Subject: William States Lee III Nuclear Station, Units 1 and 2
NPDES Permit Application
Permit Number SC0049140
Cherokee County, South Carolina

Duke Energy Carolinas, LLC
Additional Information for Draft NPDES Permit SC0049140
William States Lee III Nuclear Station
July 19, 2012

WILLIAM STATES LEE III NUCLEAR STATION
NPDES PERMIT APPLICATION REVISIONS
JULY 2012

River Intake Structure
Sheet 3 of 3
Figure A-16

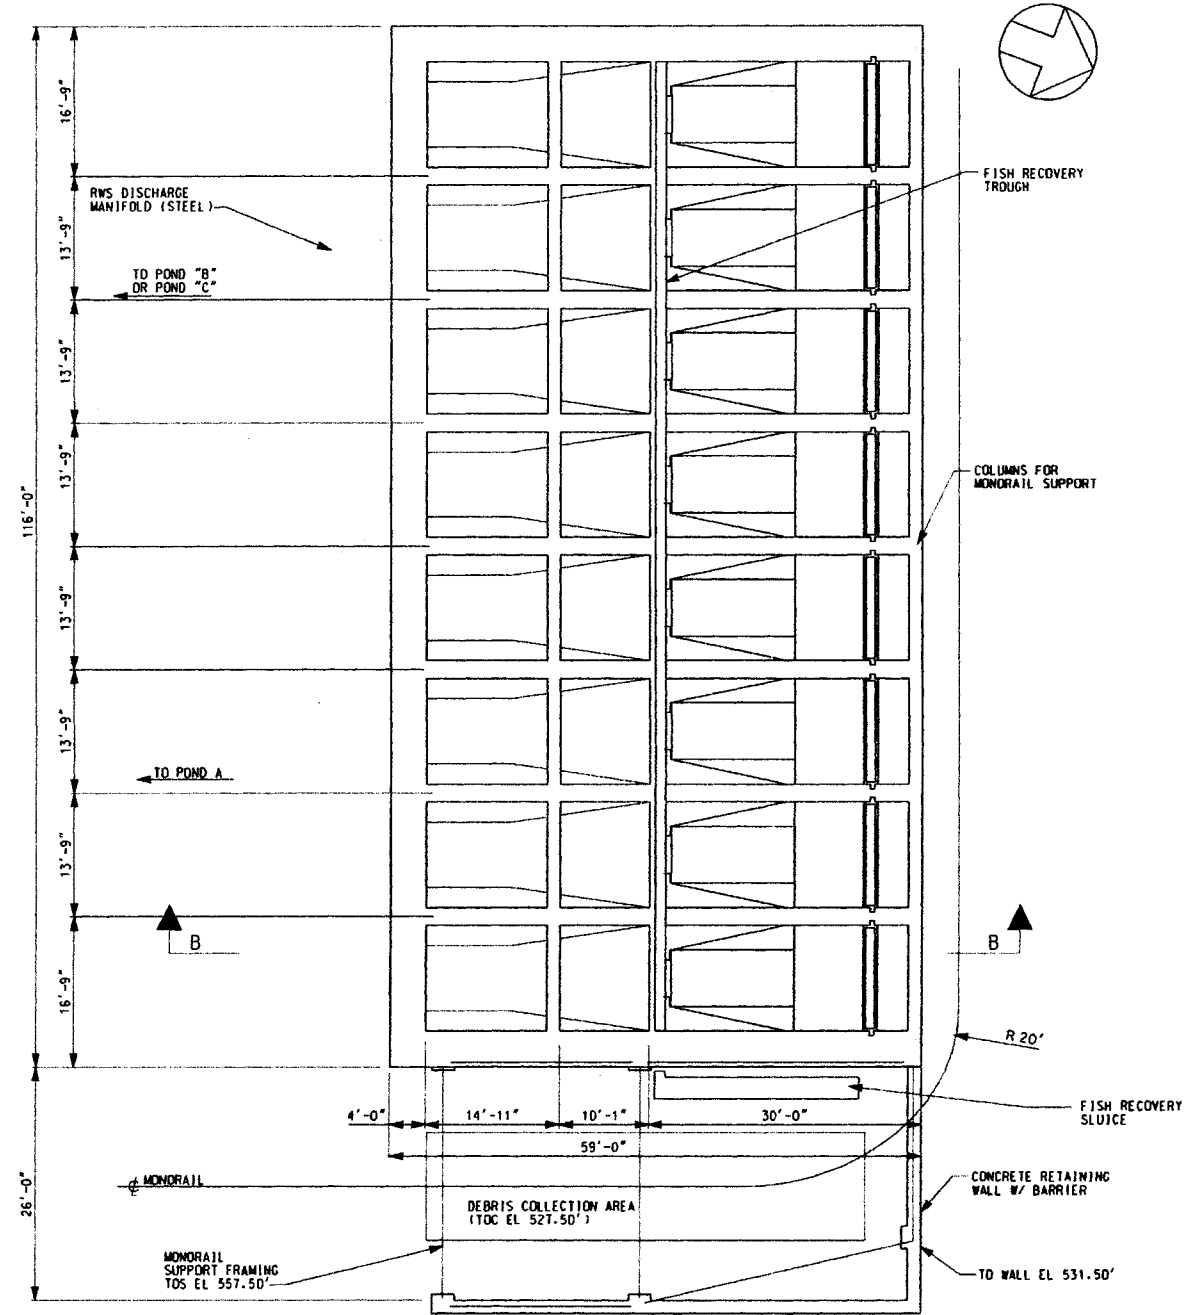
This mesh screen size will be used on the dual flow traveling screens for the Broad River Intake (Figure A-16 enclosed) for both the plant pumps and the refill pumps and also for the Make Up Pond A pumps.
